Planning Commission
Wednesday, December 4, 2024
4:00 PM
130 Kearns Road
Council Chambers
Agenda

- 3. ITEMS FOR DISCUSSION**
 - 3.a. SNOWMASS CENTER - MINOR PUD AMENDMENT CONTINUED FROM NOVEMBER 13, 2024**
[Snowmass Center Minor Amendment - Reso No 8 of 2024__draft 12032024.pdf](#)

- 3.b. LITTLE RED SCHOOL HOUSE - SPECIAL REVIEW AND SUB PLA**
[_Agenda Item Summary, LRSH - PC mtg 12-4-24.docx](#)
[1_PN for PC review of Subd Plat, 11-20-24.doc](#)
[2_Zoning, Aerial & Map Exhibits.docx](#)
[3_Site Photos, 10-10-24.docx](#)
[4_PC Reso 7, 2024 - S.R. & Plat in Public Zone for LRSH Addition.docx](#)
[5_24_1028_LRSH_Special Review Add.01.pdf](#)
[6_23065-LRSH-SubPlat-24X36-BW-Prelim-11-05-24.pdf](#)
[7_Staff Report Compliance Analysis.docx](#)

TO: BRIAN MCNELLIS, SENIOR PLANNER
FROM: MIKE HORVATH, TOWN ENGINEER
ANNE MARTENS, PUBLIC WORKS DIRECTOR
SUBJECT: MINOR PUD AMENDMENT REVIEW – SNOWMASS CENTER COMMENTS
DATE: OCTOBER 31, 2024

Section 16A-5-400-400 Subdivision Regulations

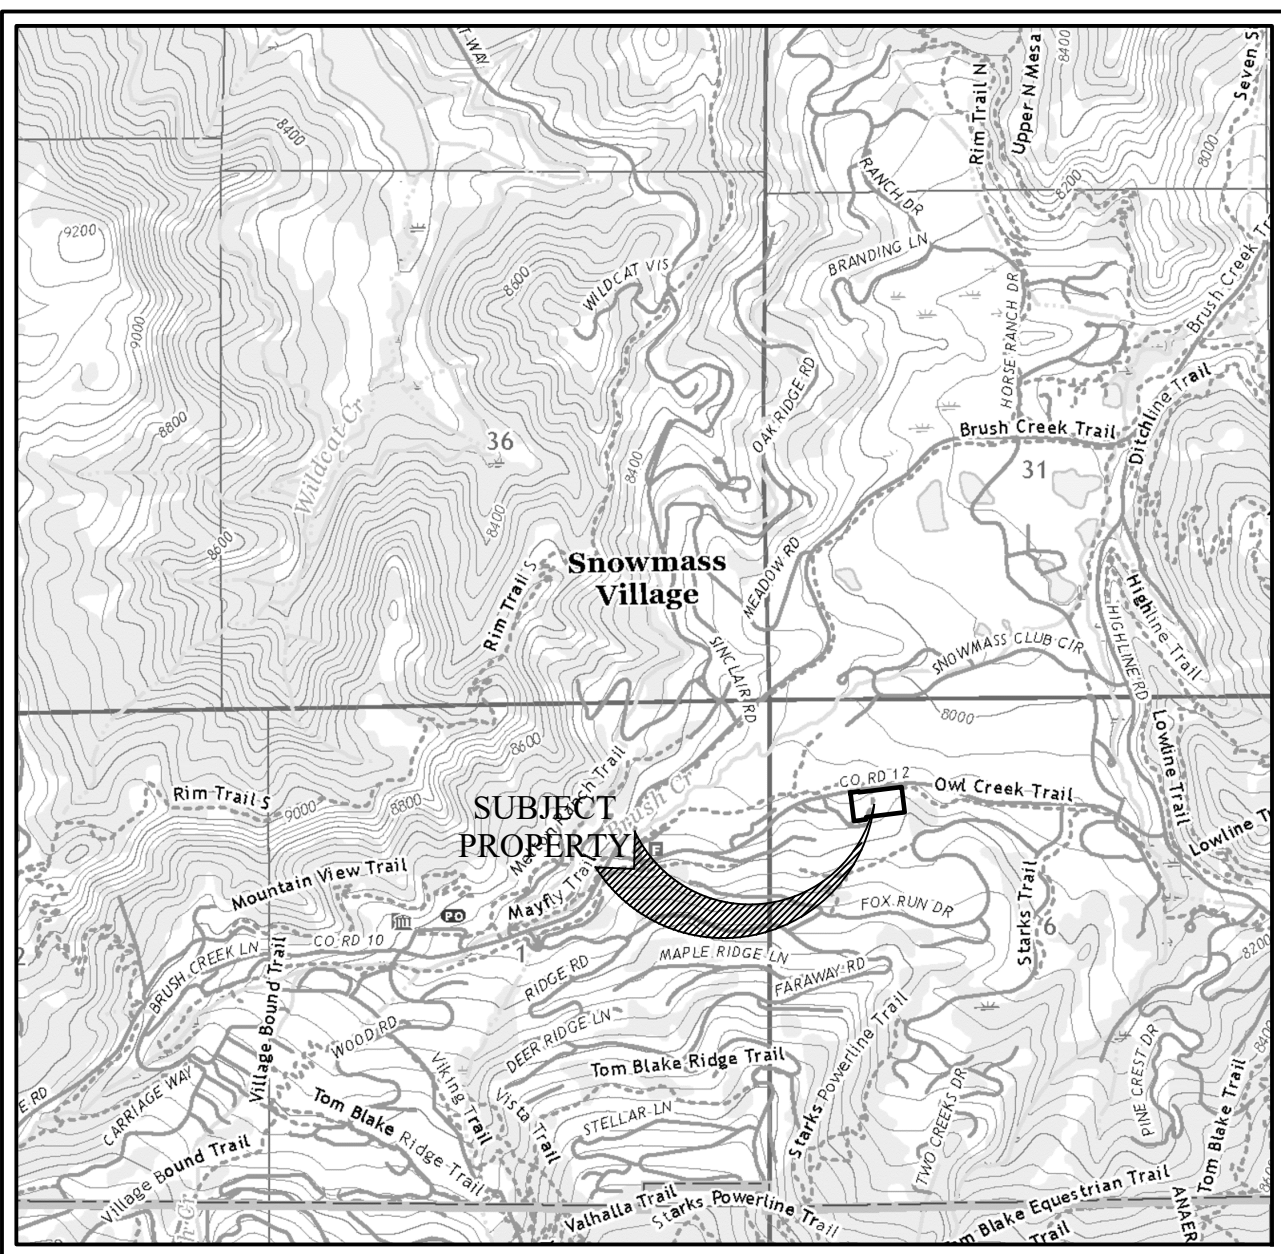
- Reference the attached plat exhibit for revisions requested.

SHEET NO.
G100

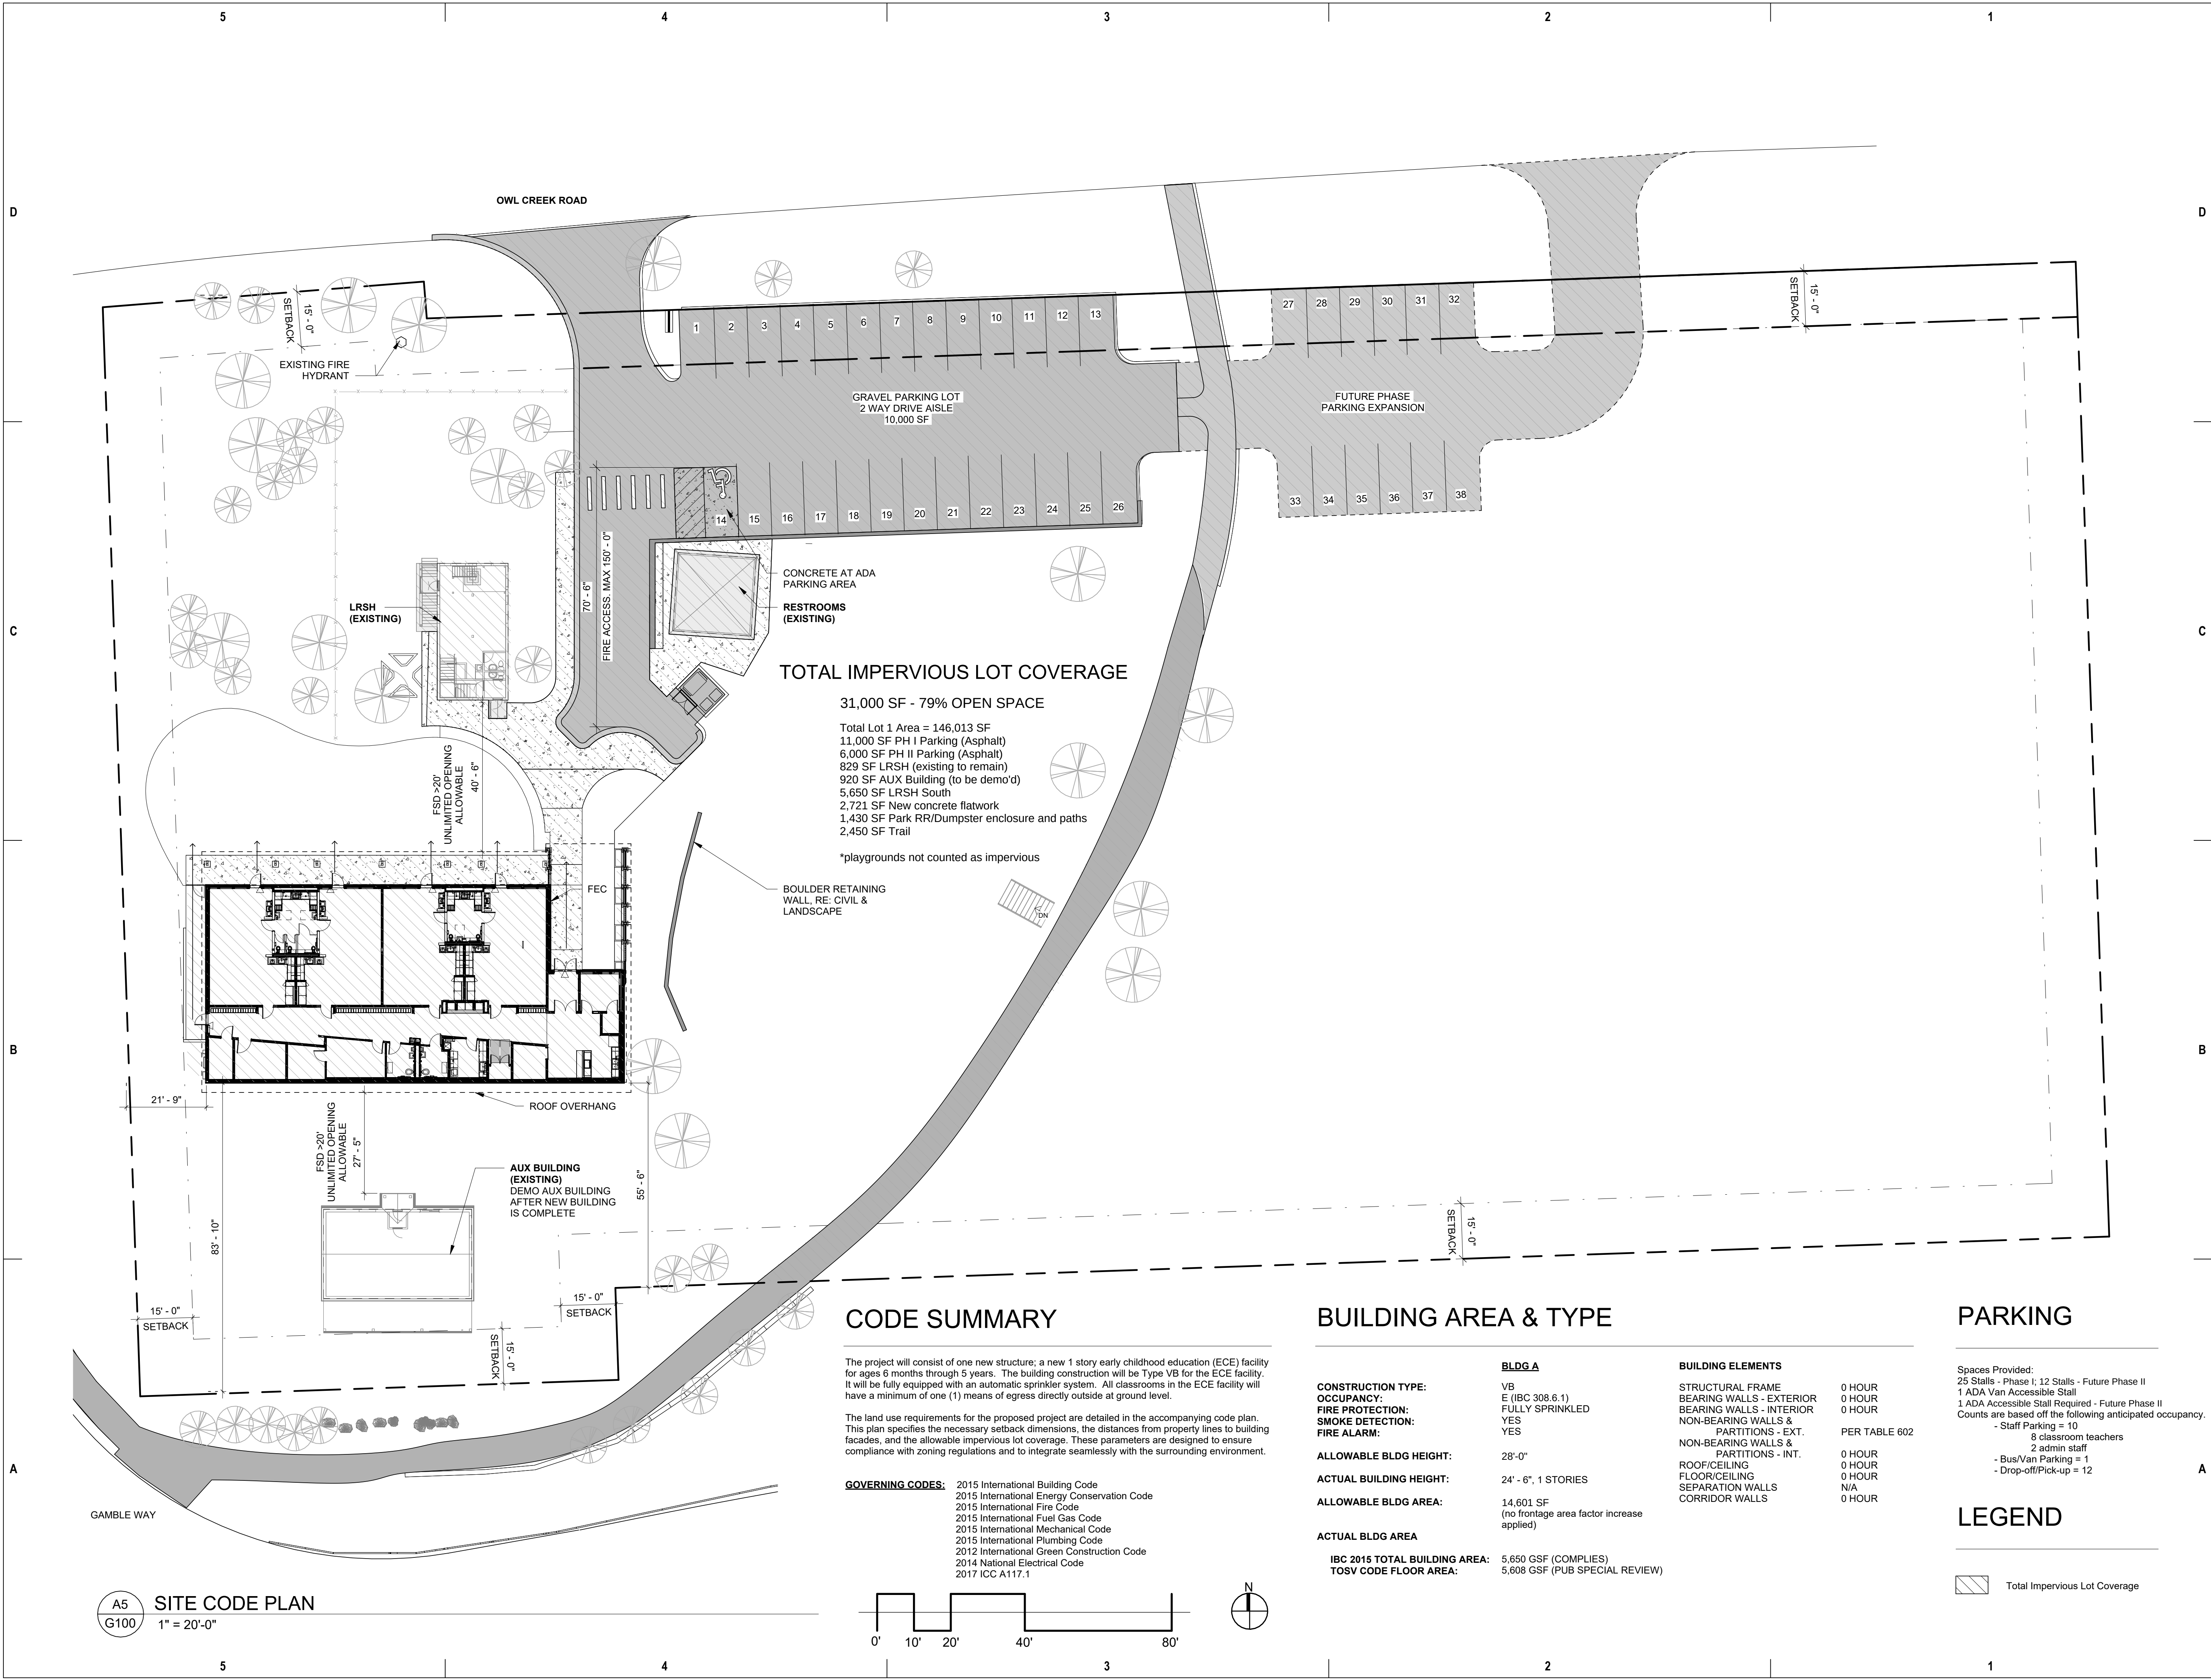
- Primary Building Height 28' maximum height (removed story reference and revised permitted height on Sheet G100; LRSH max. height 23'-0", documented on sheet A201)
- Accessory Building Height 12' maximum height
- Fence proposed at 6' H and all gate locations shown on landscape plan, reference sheet L1.1

SHEET NO.
L.1.1

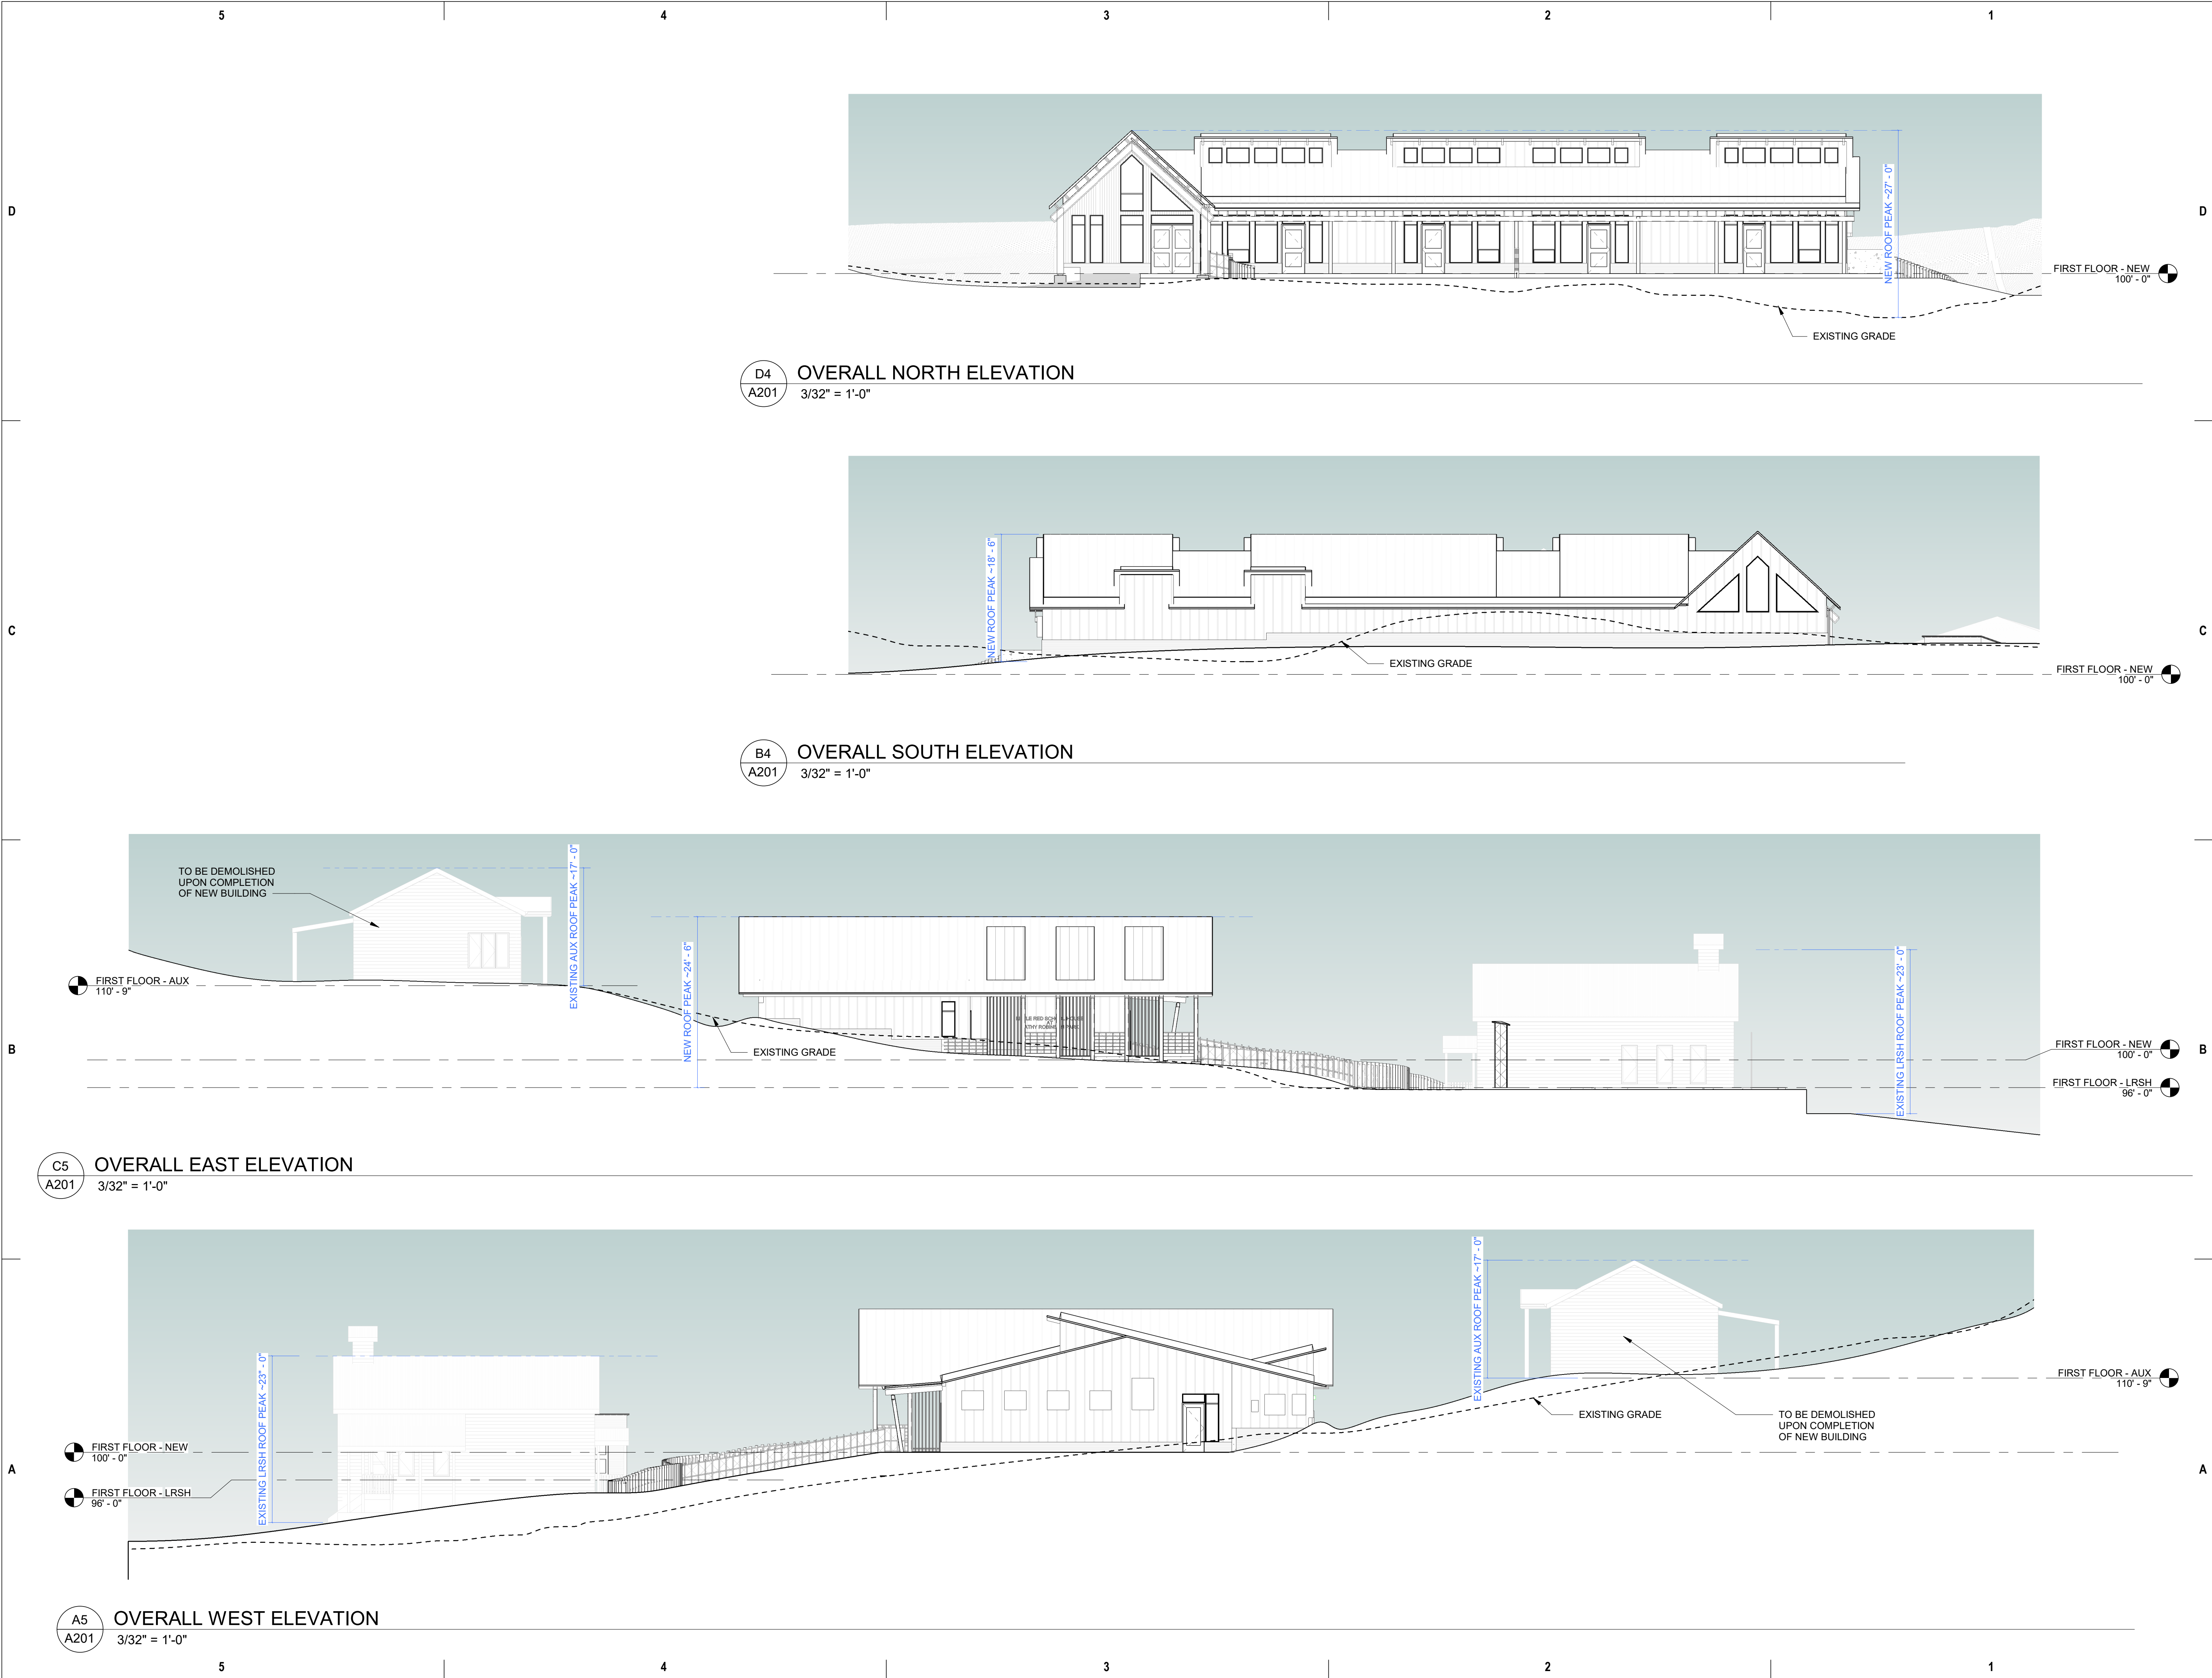
The existing schoolhouse floor area is approximately 680 square feet (or a 712 square foot building footprint per Sheet L1.1). The current auxiliary building (planned for demolition) is approximately 920 square feet in floor area.

The proposal includes a 5,608 square foot addition (or 5,648 square foot building footprint per Sheet L1.1), limited to one-story per prior ownership design meeting discussions. The maximum floor space was modified to a 0.1:1 F.A.R. which proposes an entitlement of 14,601 square feet for possible future additions or accessory structures, although such additions may require another Special Review for consideration.
